SUBJECT: LANDING GEAR HYDRAULIC SYSTEM, MODIFICATION OF PLUMBING AT MAIN GEAR ACTUATOR CYLINDER AND UPLOCK CYLINDER.

AIRCRAFT AFFECTED: BEECHCRAFT Musketeer A24R, serials MC-2 through MC-70, except MC-22, MC-23, MC-39, MC-42, MC-43, MC-63, and MC-64.

REASON FOR CHANGE: To preclude possible loss of hydraulic fluid in flight, resulting in an unscheduled extension of the landing gear.

Figure 1. View Looking up at Bottom of Left Hand Wing before Rework

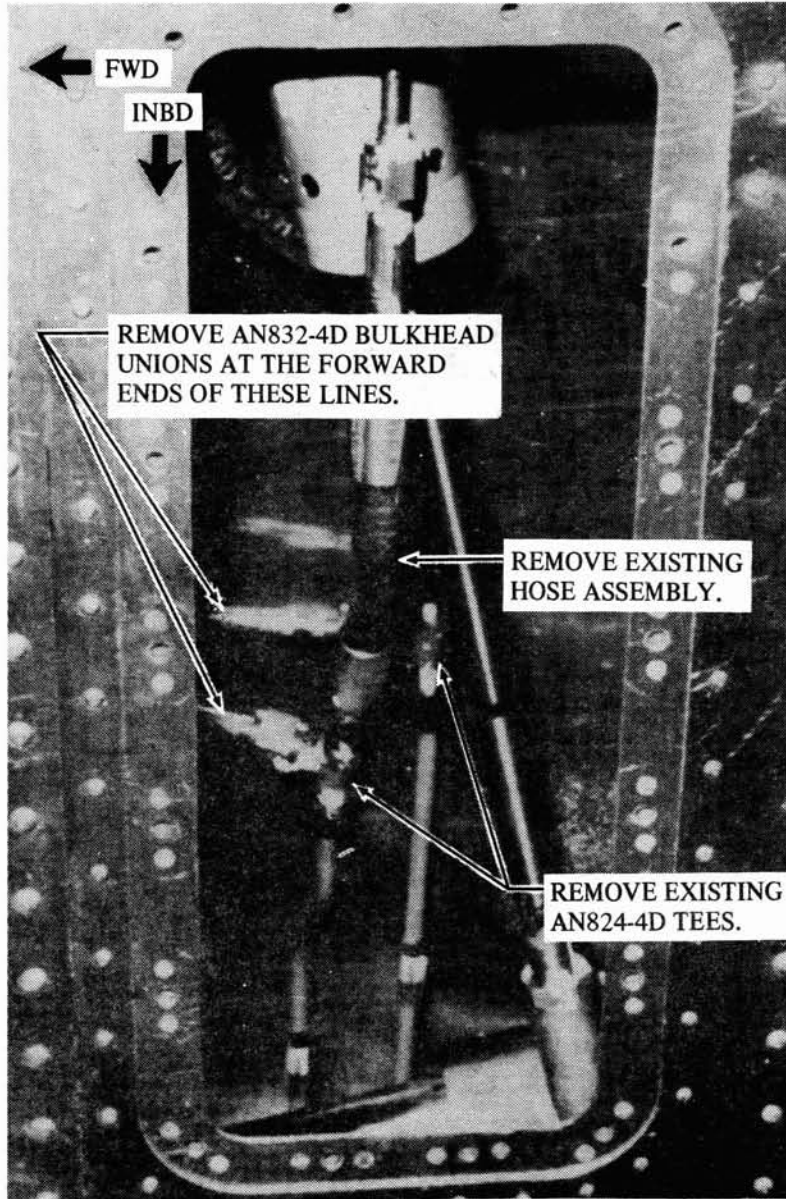
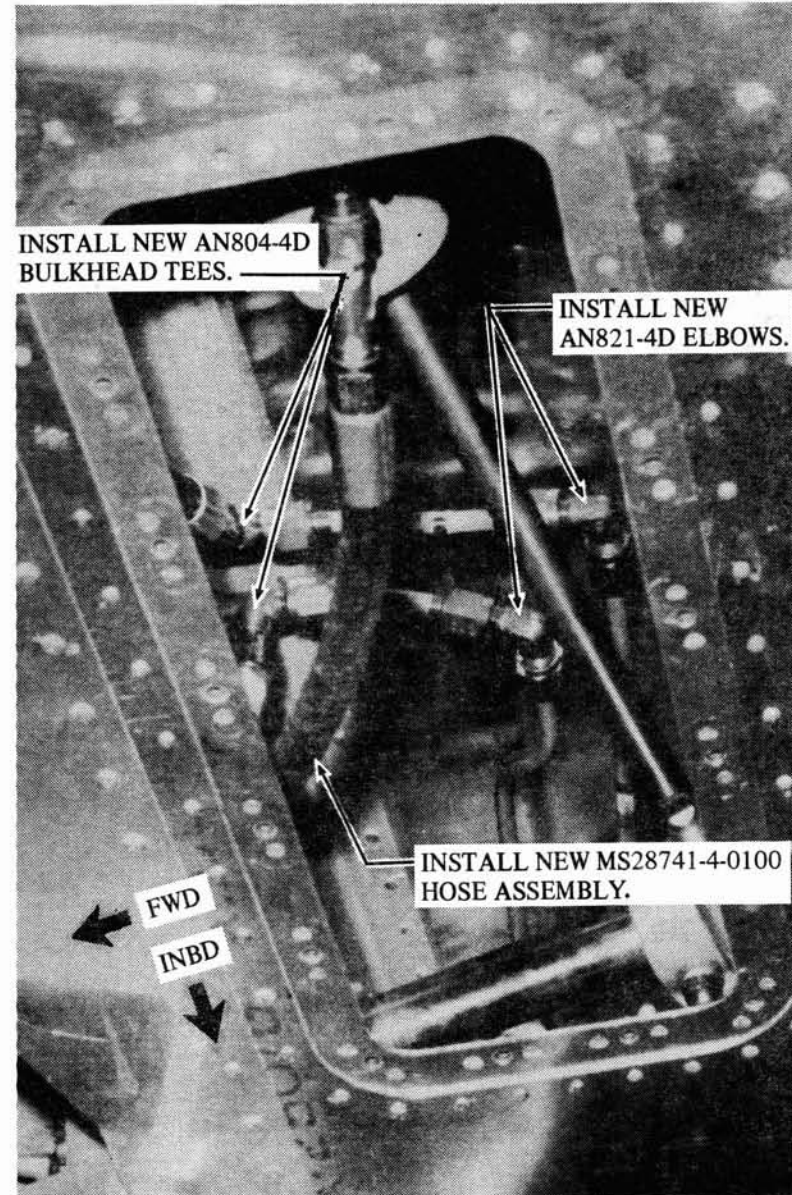
DESCRIPTION: On the BEECHCRAFT Musketeer A24R, serials noted above, it is recommended that the landing gear hydraulic system plumbing to each main gear actuator cylinder and to each main gear uplock cylinder be modified as described in the following procedure.

1. Ascertain that the battery master switch is OFF.
2. Place the airplane on jacks.
3. On the bottom of the left hand wing, remove the long rectangular access door aft of the main landing gear installation.
4. Locate the AN824-4D tee at the inboard end of each of the two landing gear hydraulic system hose assemblies. (See Figure 1.) Make certain that the hose assembly connected to the inboard-most AN824-4D tee can be identified later, then remove and discard the two AN824-4D tees.

5. With two AN821-4D elbows, join the two pairs of tube assemblies which were formerly connected to the AN824-4D tees. (See Figure 2.)
6. Disconnect the other end of the hose assembly which was disconnected from the inboard-most AN824-4D tee in Step 4 and discard the hose assembly. (See Figure 1.)
7. Locate and remove the two AN832-4D bulkhead unions (Figure 1) in the wing spar web and replace with

two AN804-4D bulkhead tees (Figure 2). Position each tee so that two fittings are on the aft side of the spar web. On the forward fitting of each tee, install an AN960-716L washer on the aft side of the spar web, and install two AN924-4D nuts on the forward side of the spar web. Connect the two pairs of tube assemblies, formerly joined by the two AN832-4D bulkhead unions, to the forward and aft fittings of the two AN804-4D bulkhead tees.

8. Connect the free end of the remaining hose assembly to the outboard-most AN804-4D bulkhead tee.

9. Connect a new MS28741-4-0100 hose assembly to the other AN804-4D bulkhead tee (Figure 2), and to the fitting in the inboard end of the actuator cylinder.
